LIGO-D960444-C-D

LASER INTERFEROMETER
 GRAVITATIONAL-WAVE OBSERVATORY
 SITE NO. 1 - HANFORD, WASHINGTON

TITLE: PLUMBING
 MID & END STATIONS
 FLOOR PLAN

REVISIONS: **WA-P-211**

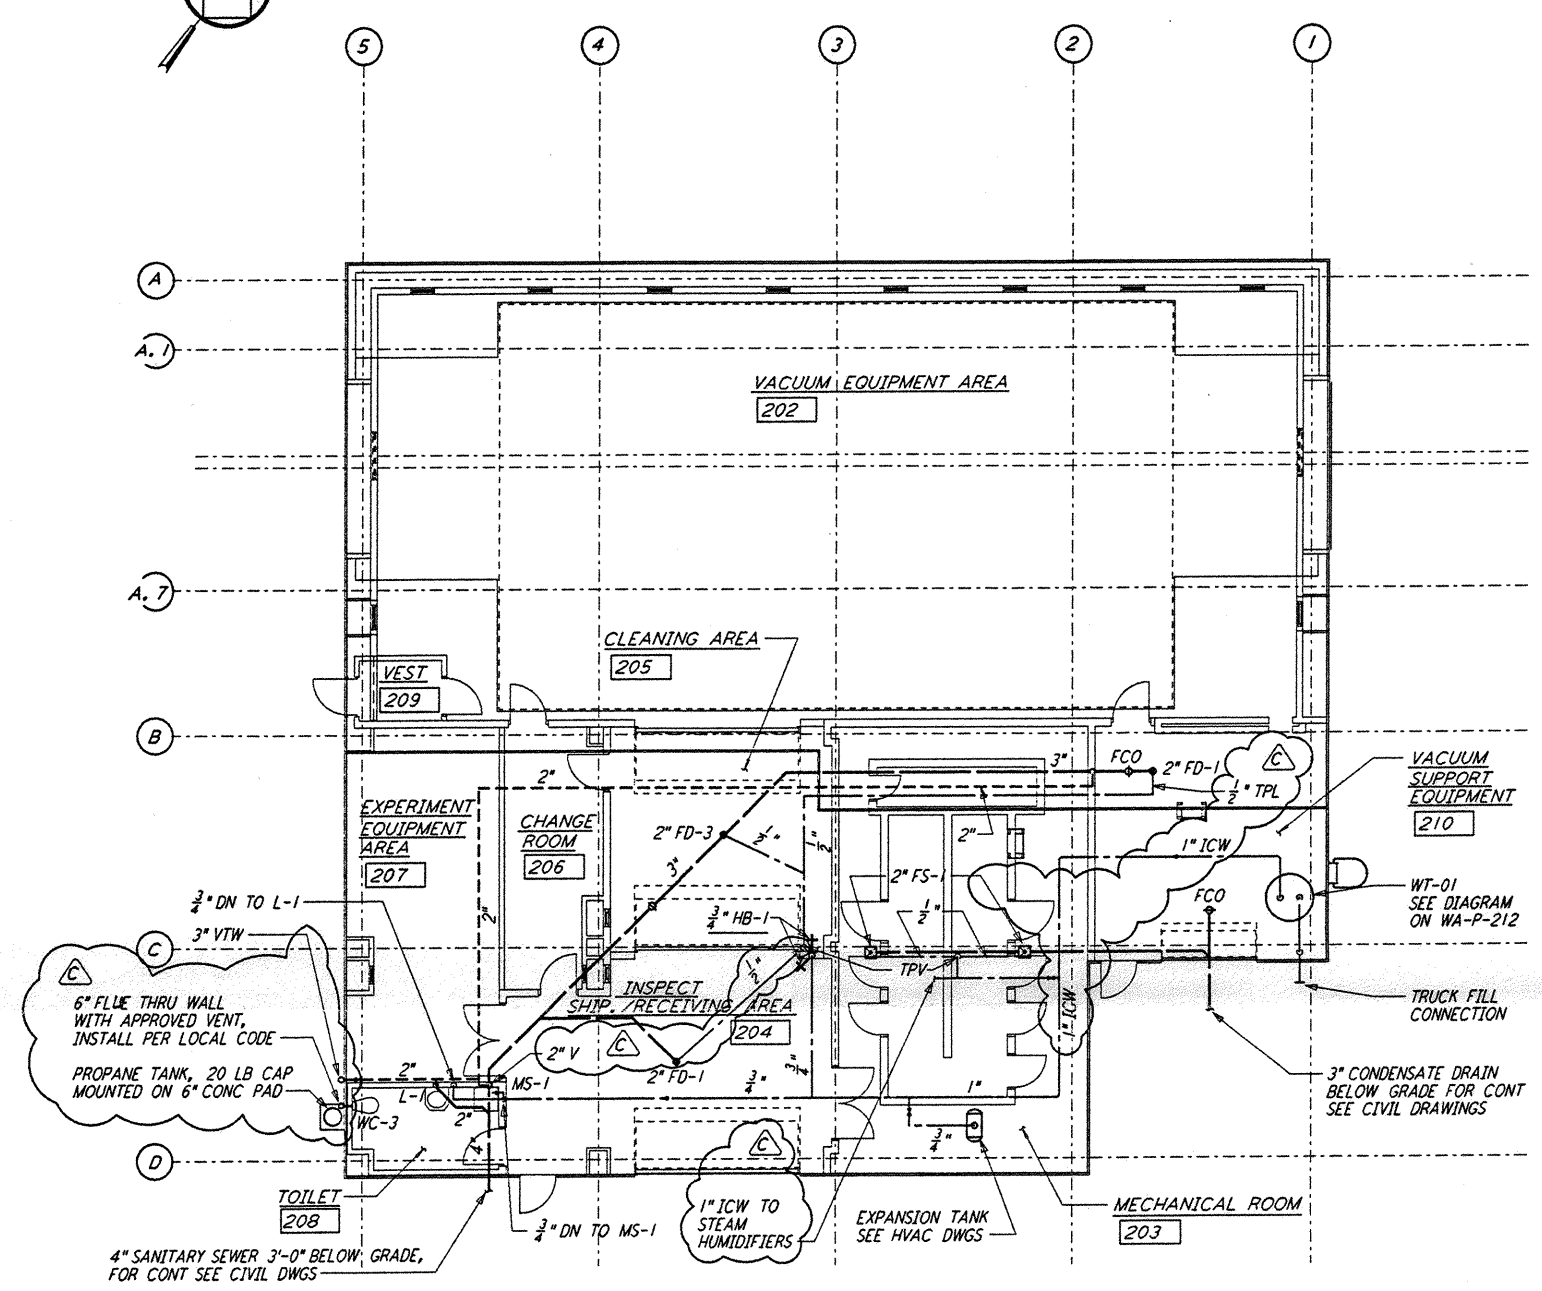
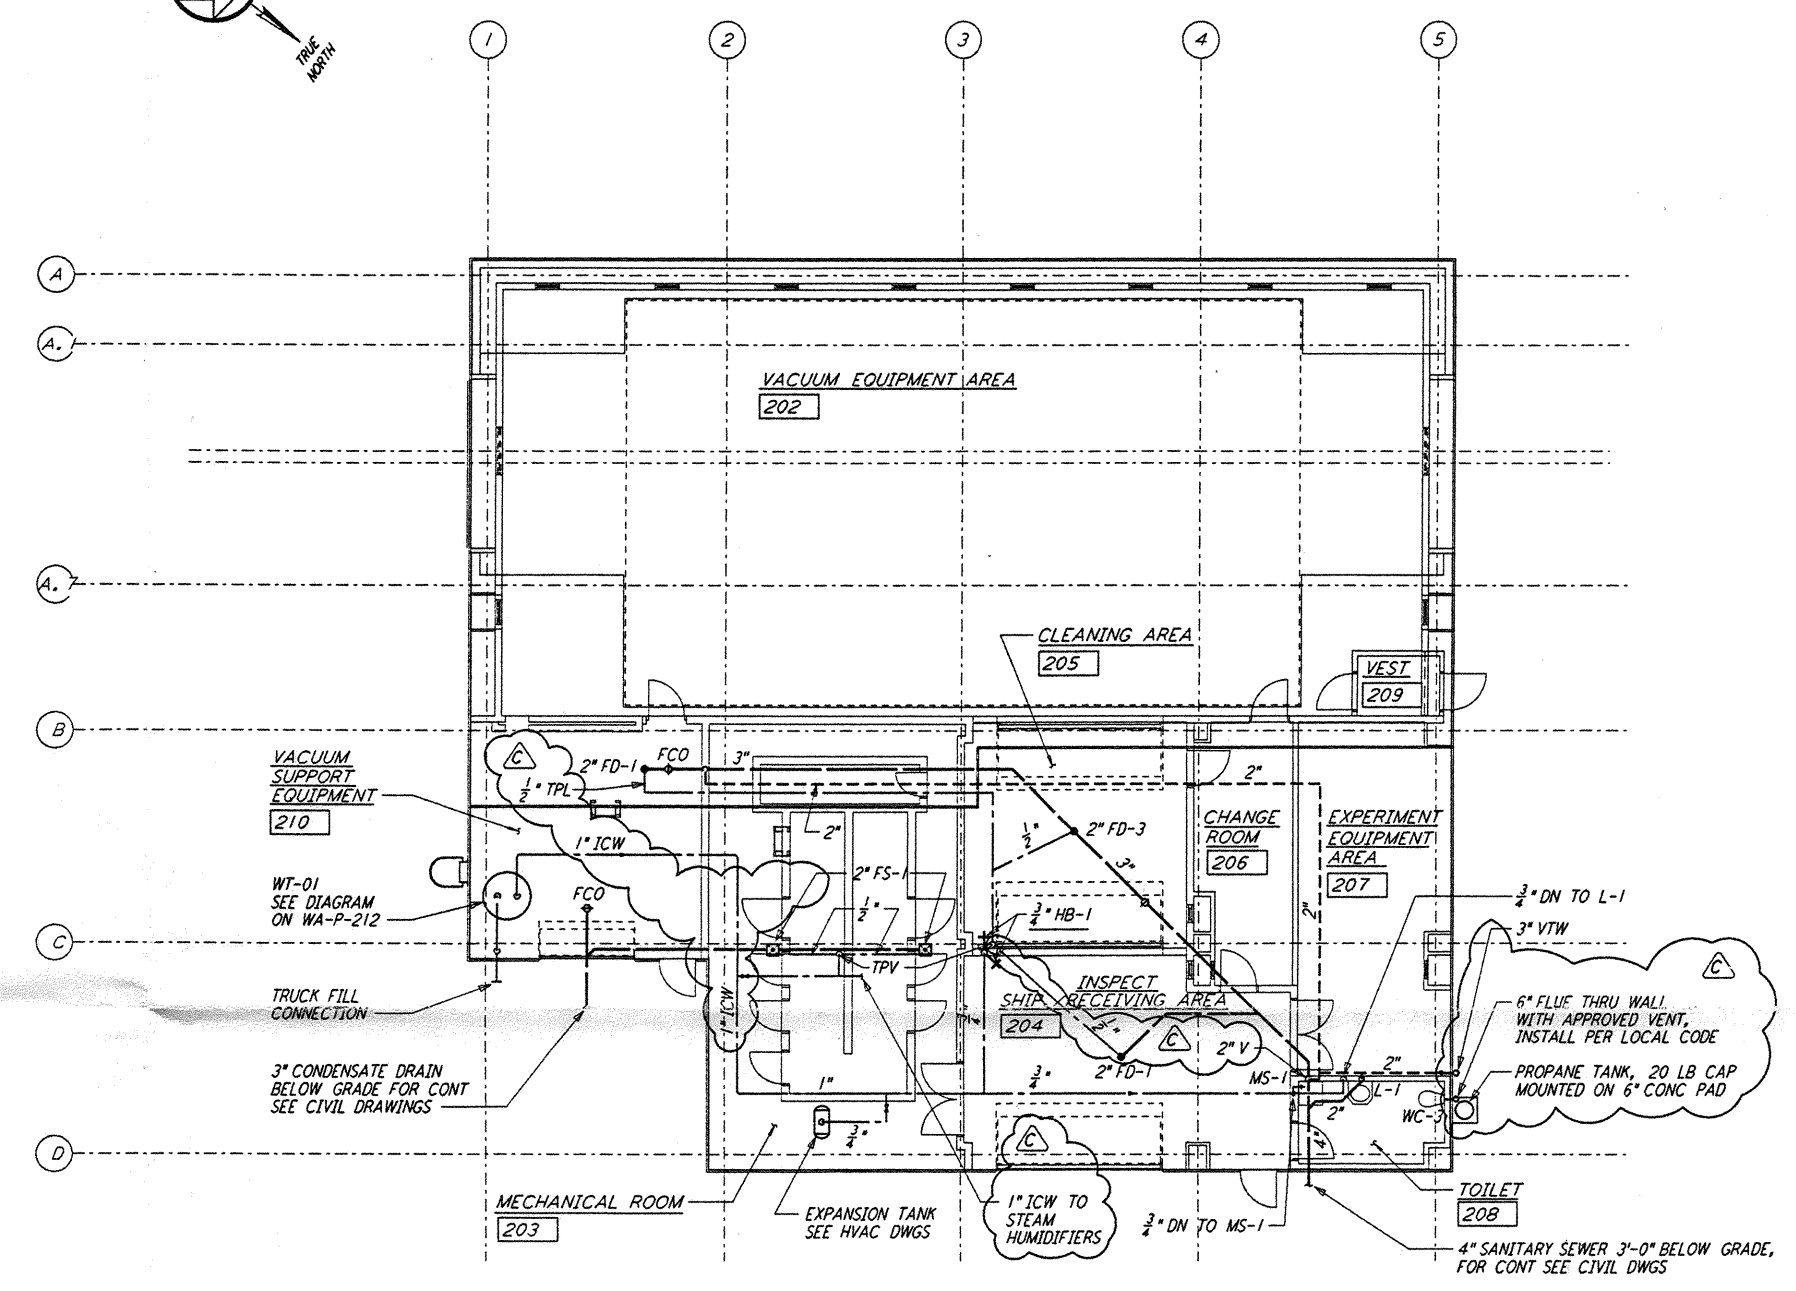
NOTE:
 1. PROVIDE SIGNS AT ALL WATER OUTLETS IN THE MID AND END STATIONS STATING "DANGER - UNSAFE WATER"
 2. THE WORK MARKED BY HAND ON THIS DRAWING IN REV "B", DATED 4-19-96 HAS BEEN RESTORED TO THIS CONTRACT.
